ADDENDUM NO. 2

DATE: April 13, 2015

Contract 14-C-00054; Blue Sink Water Main

Table 1: Modeled AVAR Summary

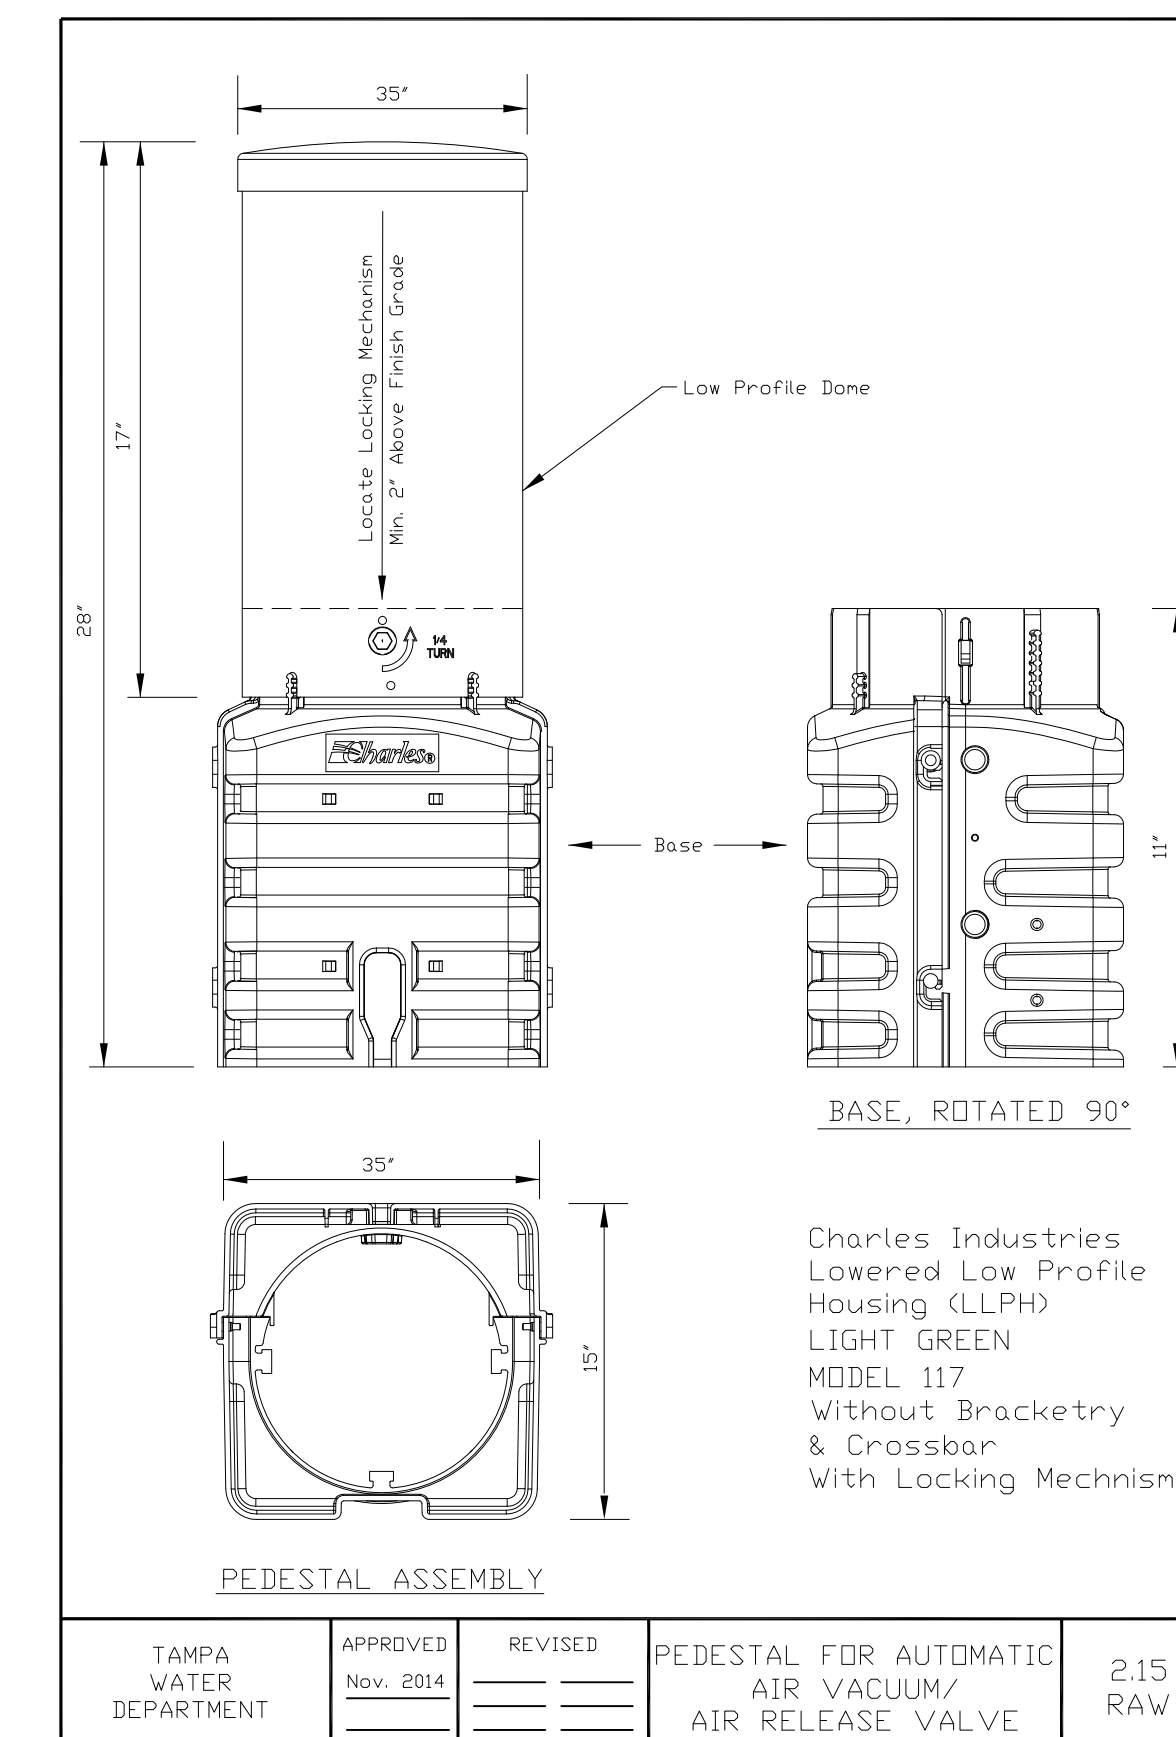
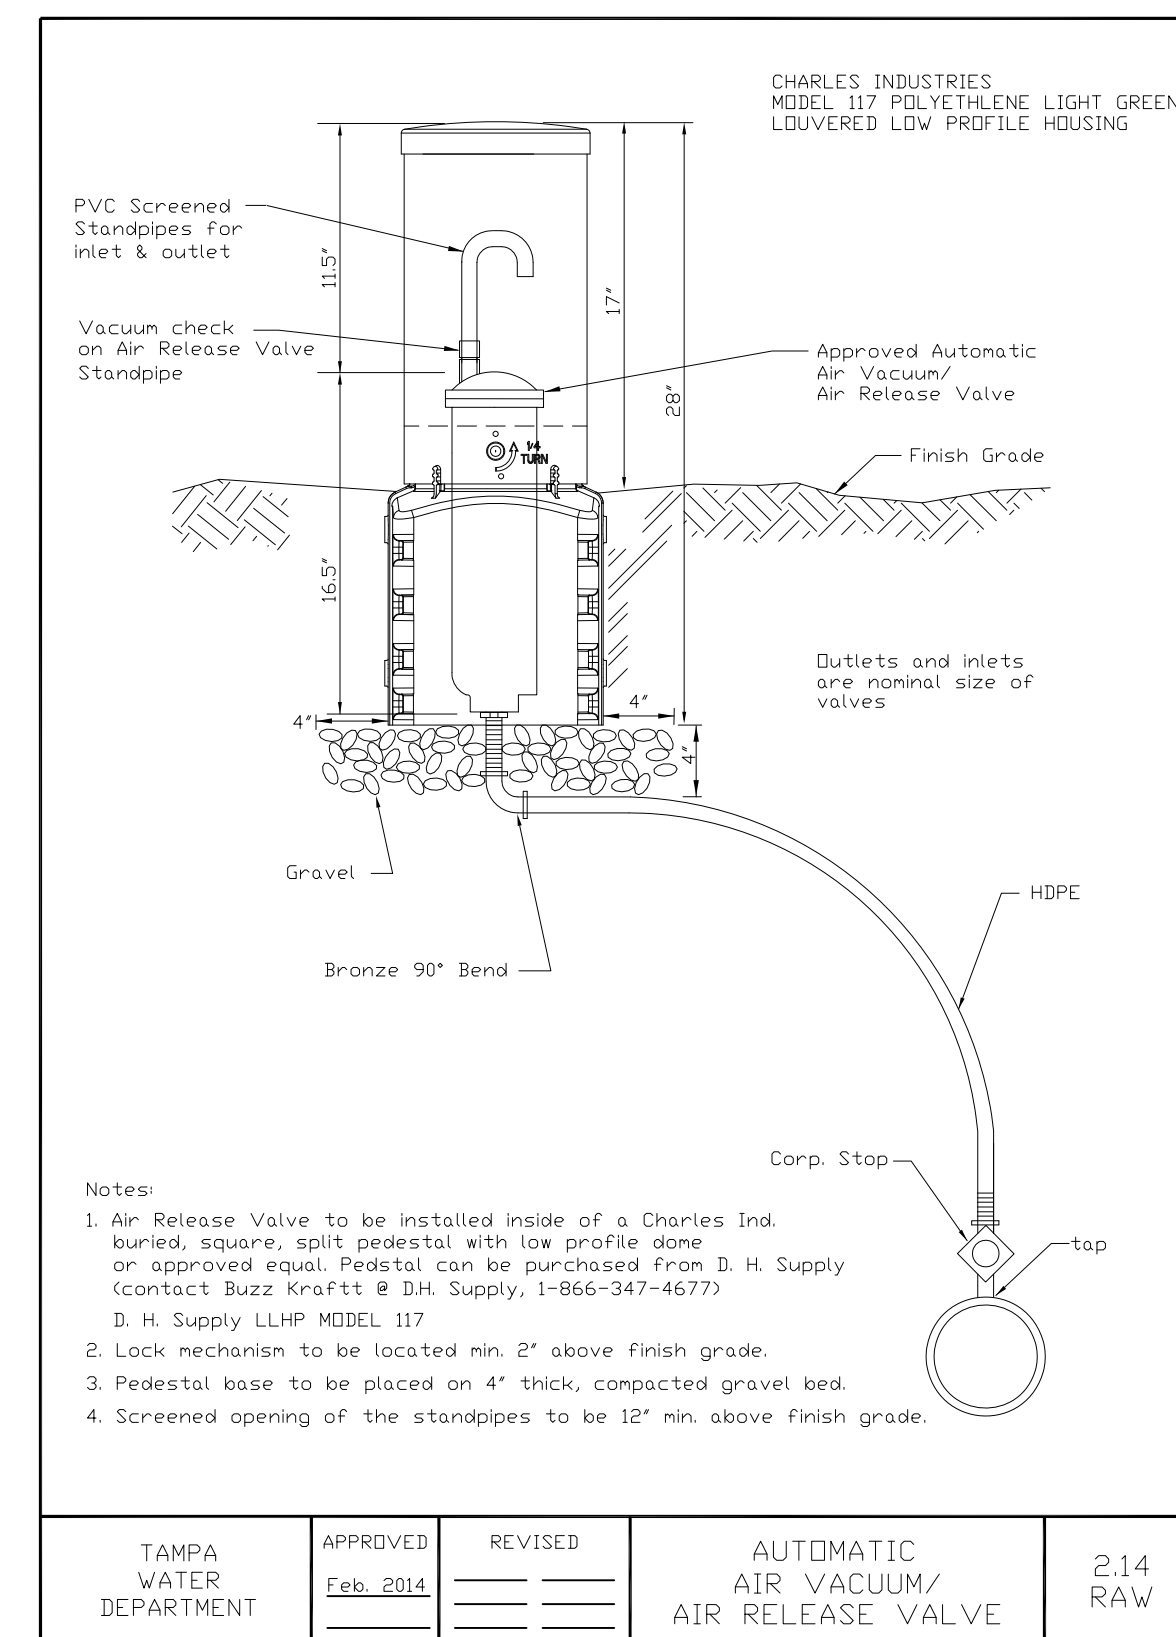
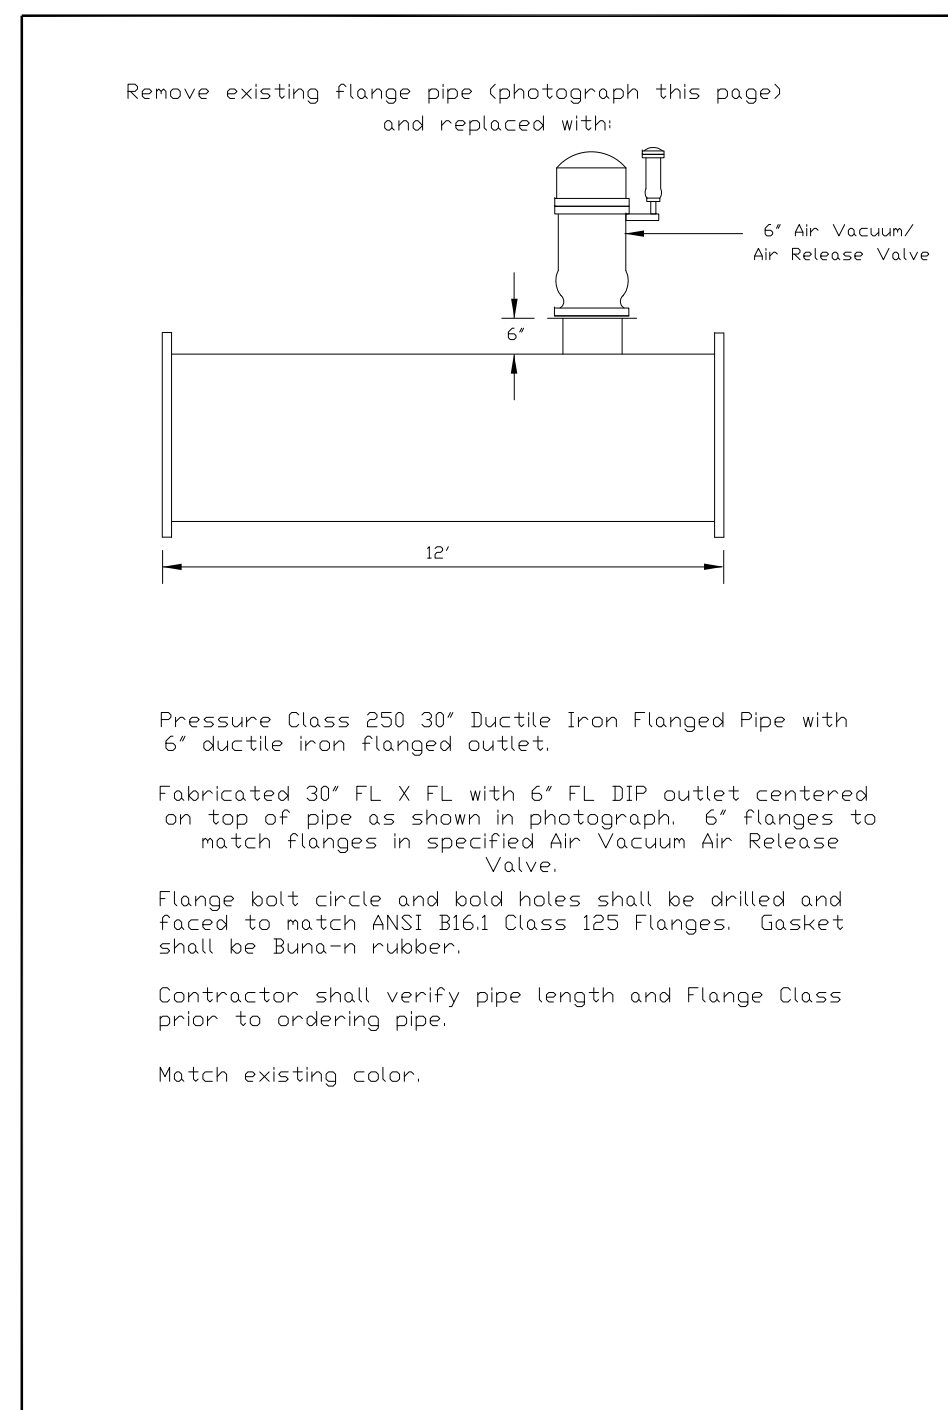
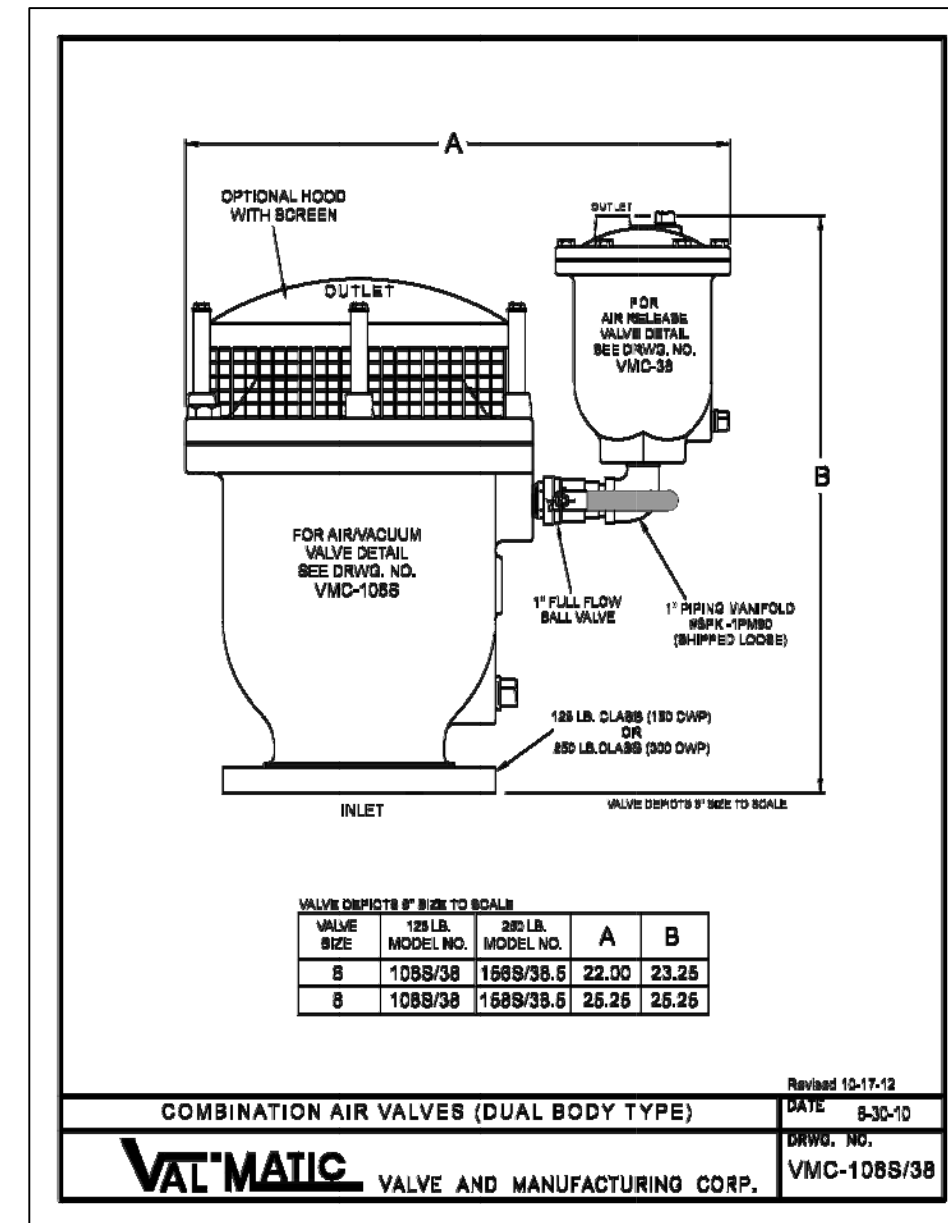
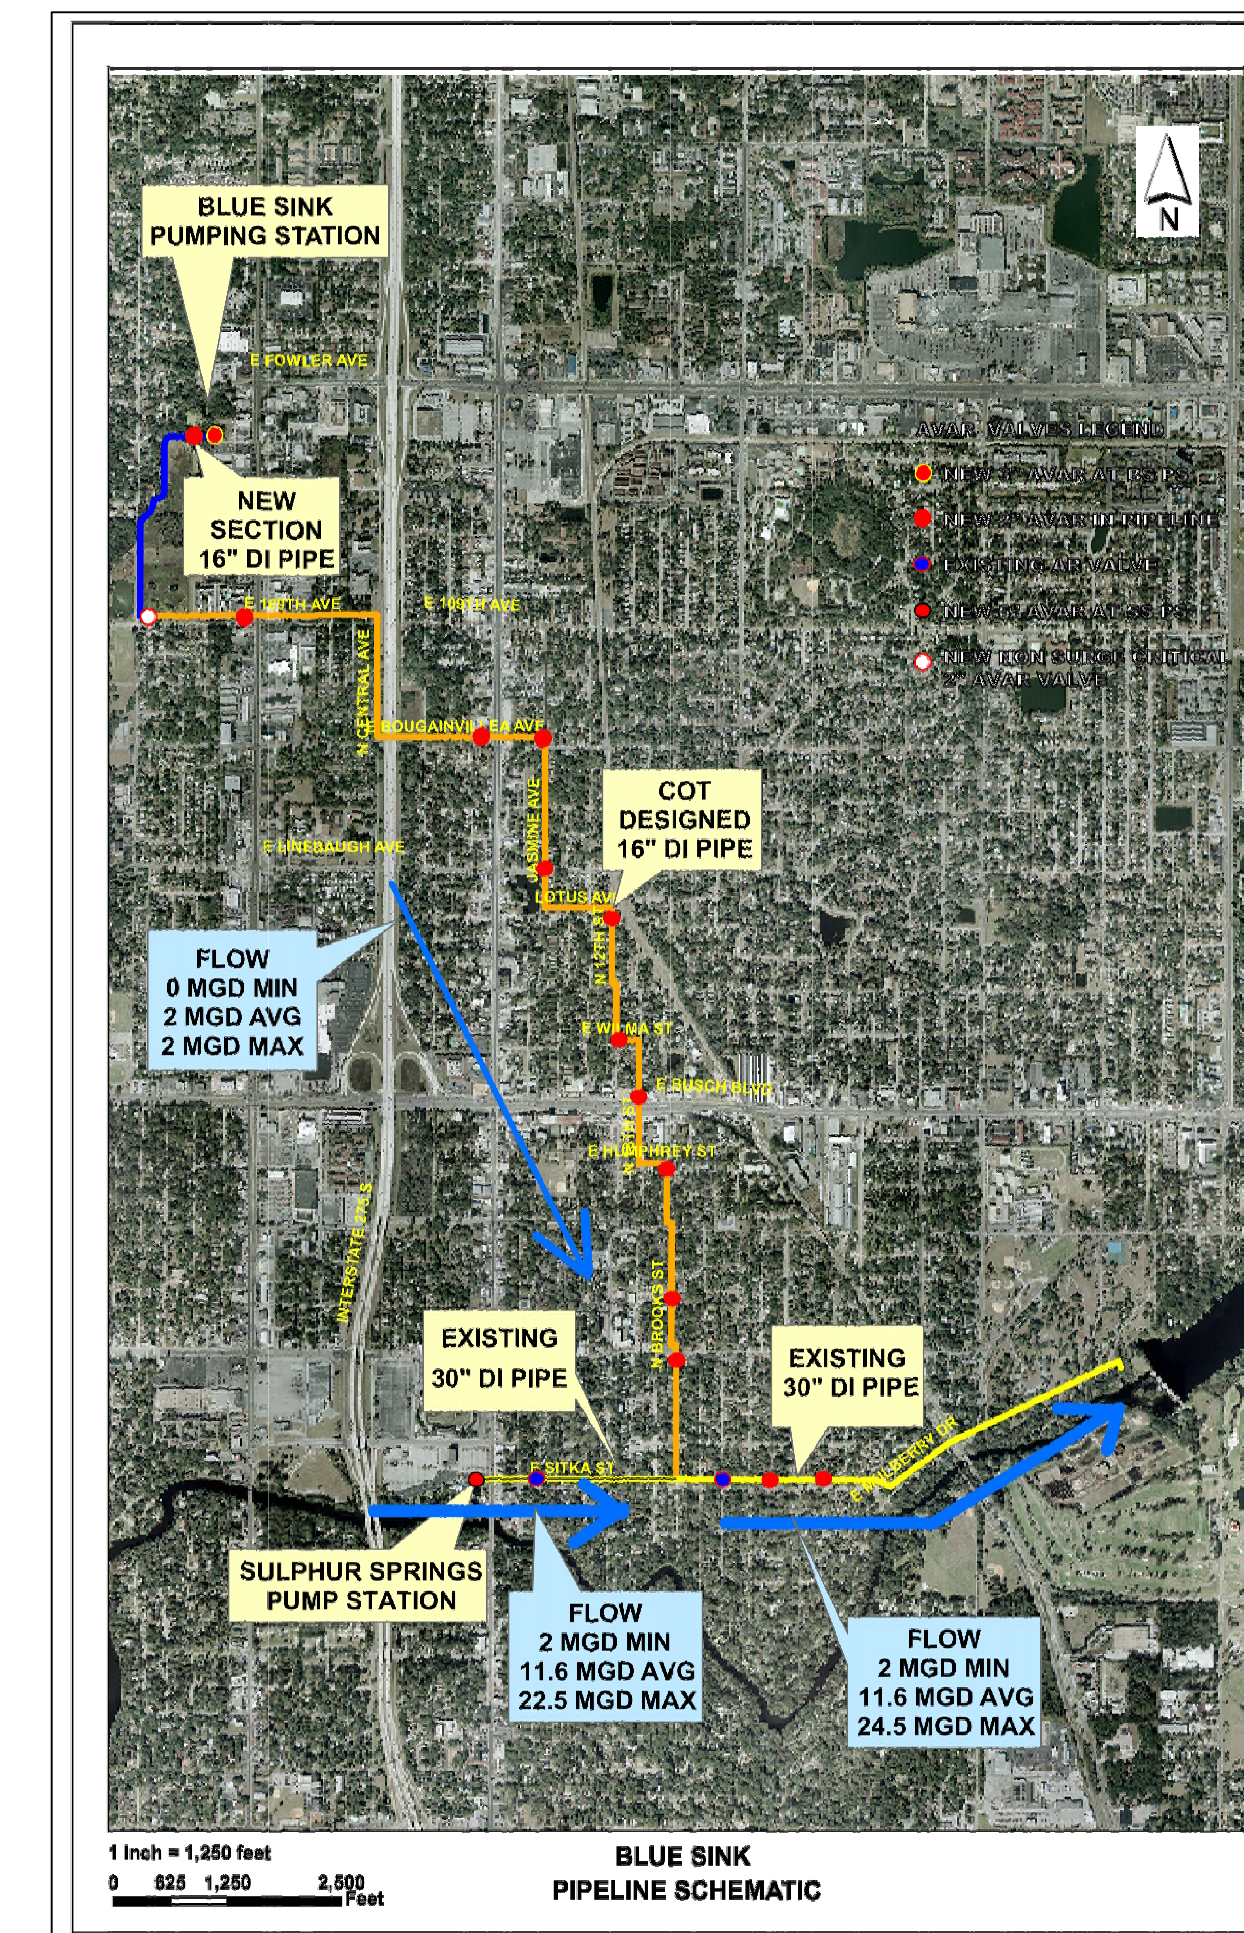
- In Table 1: Modeled AVAR Summary above, six air vacuum air release valves are not shown in the project drawings.
- Valve 1 is to be placed on the 16" discharge header pipe at the highest point at the blue sink pump station.
- Valve 2 is to be placed on the 30" discharge header pipe at the highest point at the Sulphur Springs pump station on Nebraska Avenue. Details are provided on this sheet.
- Valves 3 through 6 are to be placed at various distances from the Sulphur Springs pump station along Sitka Avenue. These valves shall be tapped as shown in standard details 2.14 and 2.15 on this sheet. Pay Items for performing operations are detailed in the Contract Pay Items.
- Cutting pavement and restoration of pavement will be required. For estimating purposes, assume a trench width of 5' x 10' with 20' of 2" HDPE tubing.
